IOWA METHODIST HOSPITAL

I am writing in response to your letter of October 29, 1974 for additional information for a cobalt-60 teletherapy license.

The original shielding calculations could not be found. What has been done is a set of shielding calculations using NCRP No. 34 to show that the shielding is adequate. However, before the room is put into use a radiation survey will be done, to insure safe radiation levels in the adjacent areas.

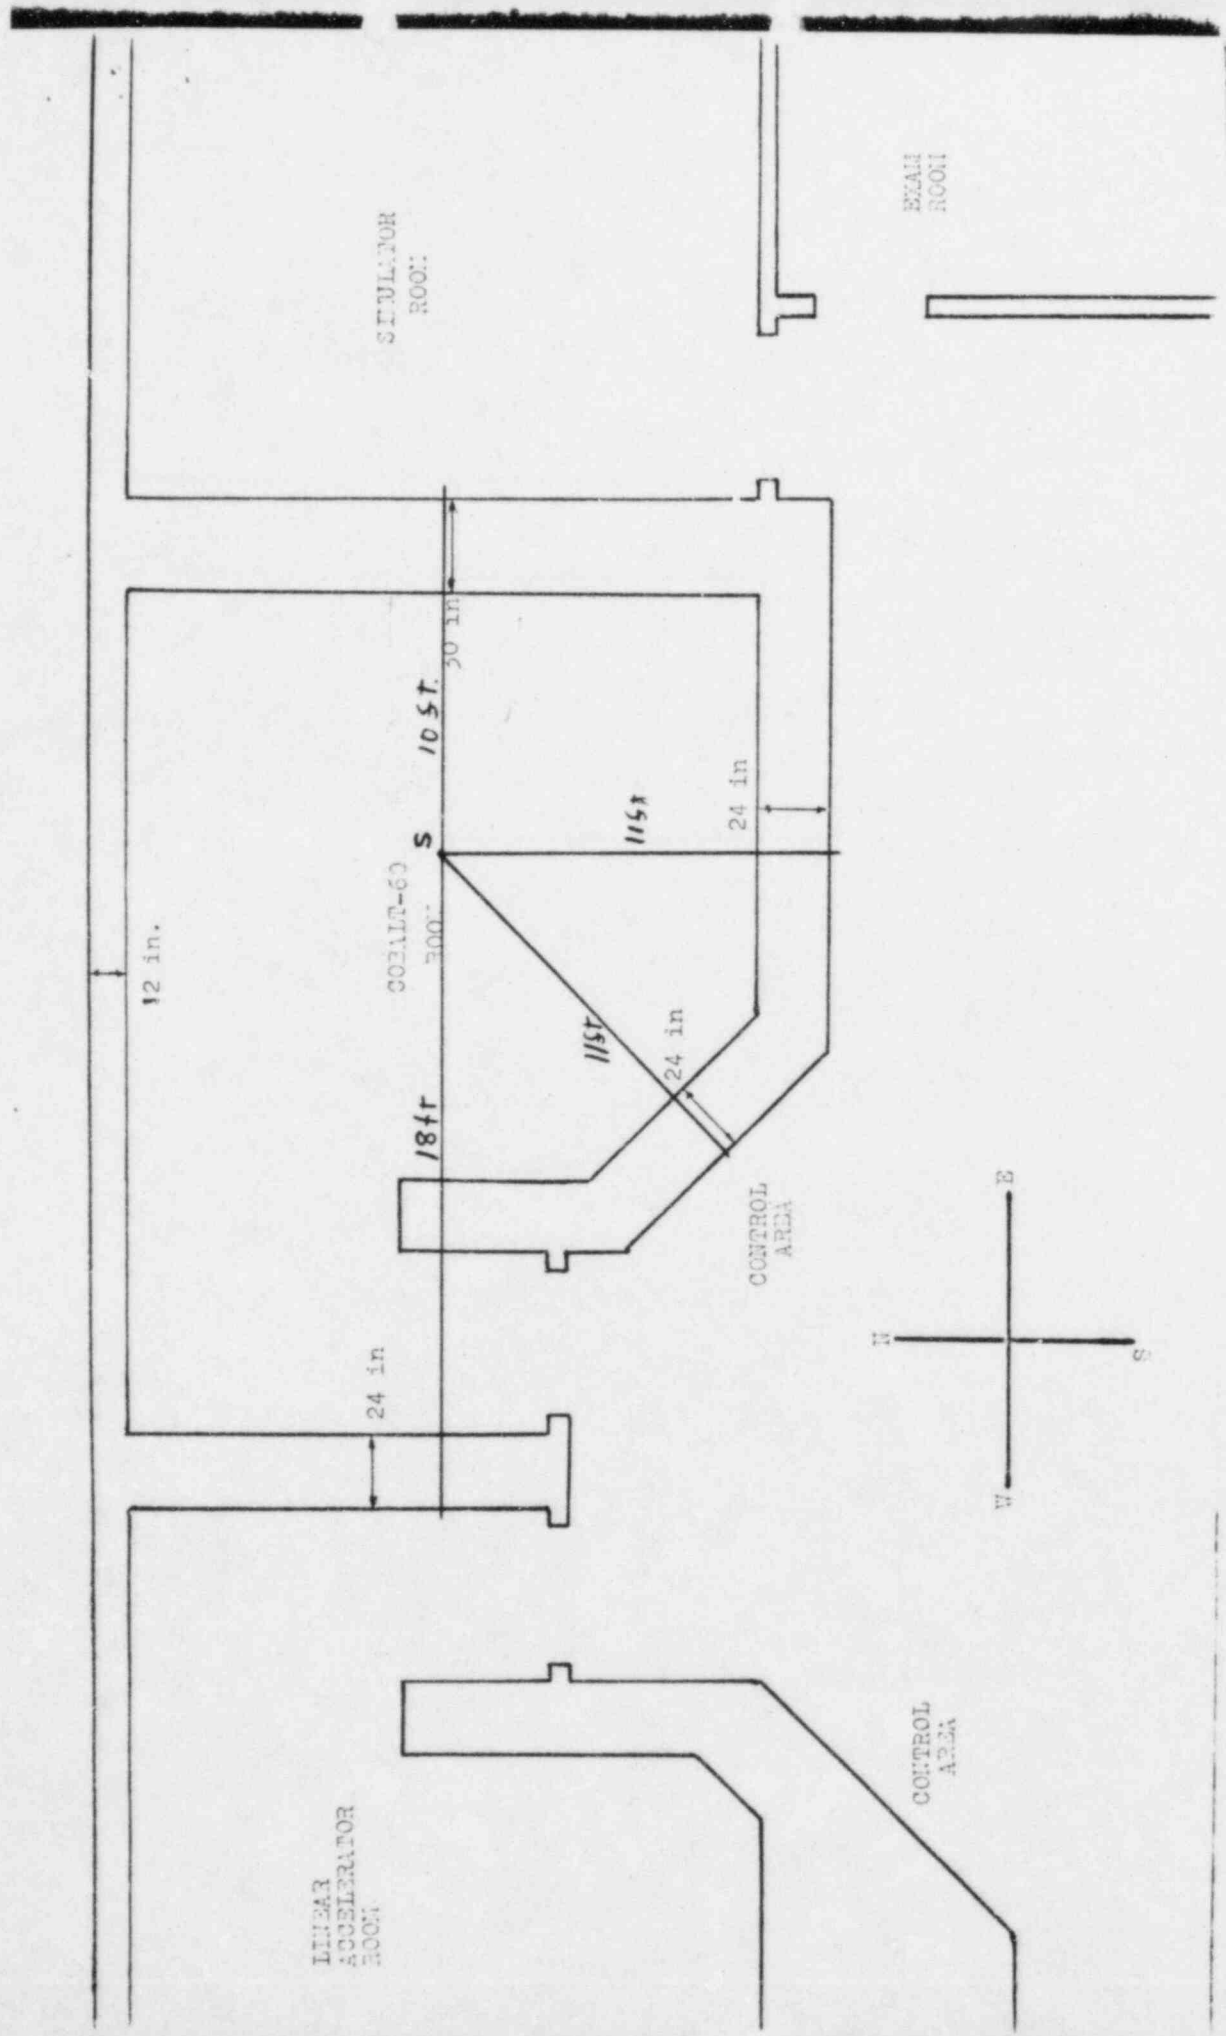
S in the figure is the source location. Shielding calculations need only to be done along the four radii to walls in the figure plus to the ceiling. This being because the machine can only point at the floor on the north wall and these regions are unexcavated non-accessible areas for which shielding calculations need not be done. The radiation to walls under consideration is scattered or leakage. The area above the room is a non-controlled area; the rest are controlled areas. The distance to the south wall and to the control area is the same, hence their calculations are the same.

The calculations require 17 inches of concrete. The wall has 24 inches

The calculations require 18 inches of concrete. The wall has 24 inches

The calculations require 18 inches of concrete. The wall has 30 inches.

The calculations require 27 inches of concrete. The ~~ceiling~~ ceiling has 36 inches
